OMAouter measurement with SSPRQ

Laurent Alloin, Eric Maniloff, Amitkumar Mahadevan
Ciena

IEEE Draft P802.3dj/D3.0
16 February 2026

Figure 180-8—Example power levels P₀ and P₃ from PRBS13Q test pattern

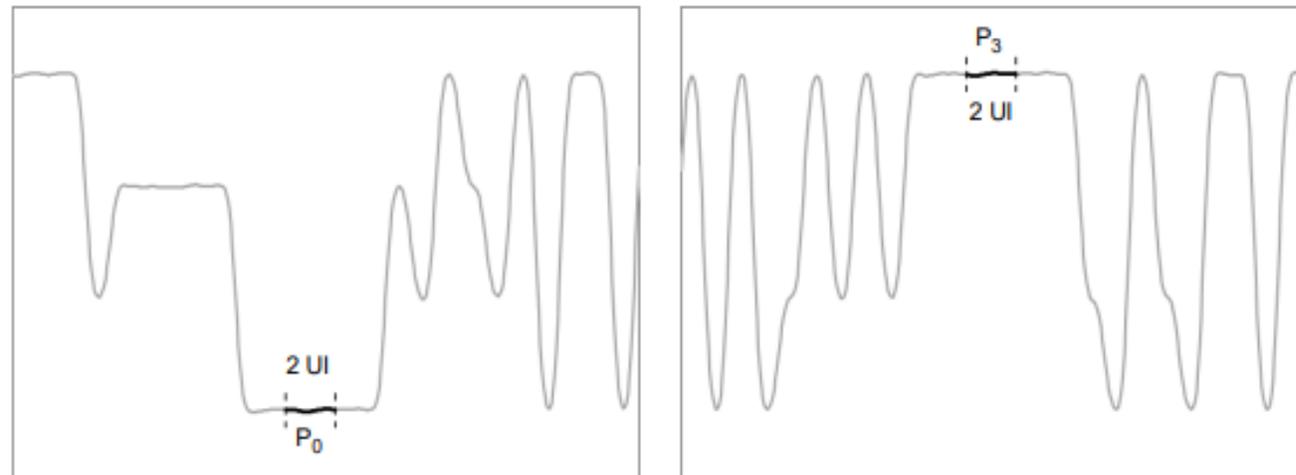
However, SC180.9.5 is tailored around the PRBS13Q signal structure !

The OMA_{outer} of each lane shall be within the limit given in Table 180-7. The OMA_{outer} is measured using a test pattern specified for OMA_{outer} in Table 180-14 as the difference between the average optical launch power level P₃, measured over the central 2 UI of a run of 7 threes, and the average optical launch power level P₀, measured over the central 2 UI of a run of 6 zeros, as shown in Figure 180-8. OMA_{outer} is measured using the waveforms captured at the output of the reference receiver defined in 180.9.2.

Proposed exception:

“When measured with SSPRQ, OMA_{outer} is measured as the average of the difference between the average optical launch power level P_3 , measured over the second and third UI of all runs of 7 threes or more, and the average optical launch power level P_0 , measured over the second and third UI of all runs of 6 zeros or more.”

Figure 180-8—Example power levels P_0 and P_3 from PRBS13Q test pattern

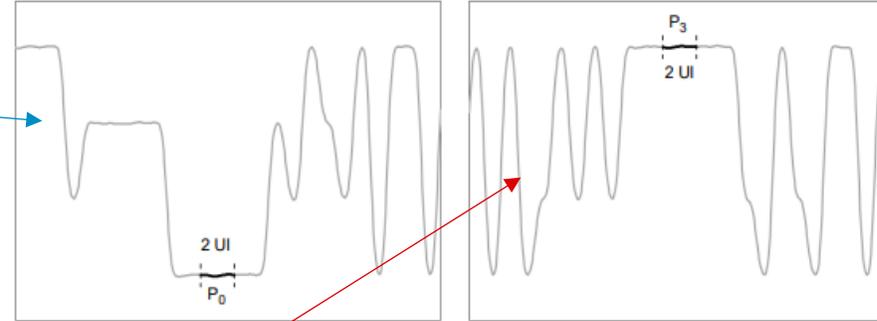
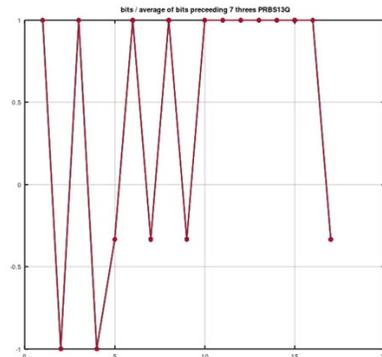
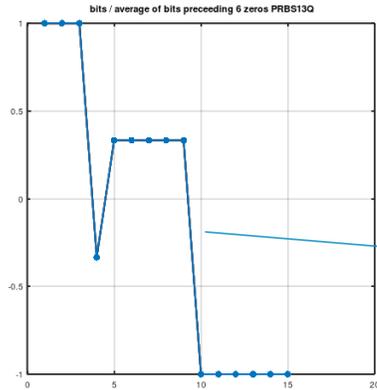
OMA_{outer} measured on a PRBS13Q benefits from some “alternating” patterns that break the impact of a long tail impulse response on the OMA_{outer} estimate, especially when a reflection is constructive (systematic tail >0) or destructive (systematic tail <0)

However, the PRBS13Q pattern is fixed; averaging across sequences will not further reduce the residual impact of the long tail in the OMA_{outer} estimate.
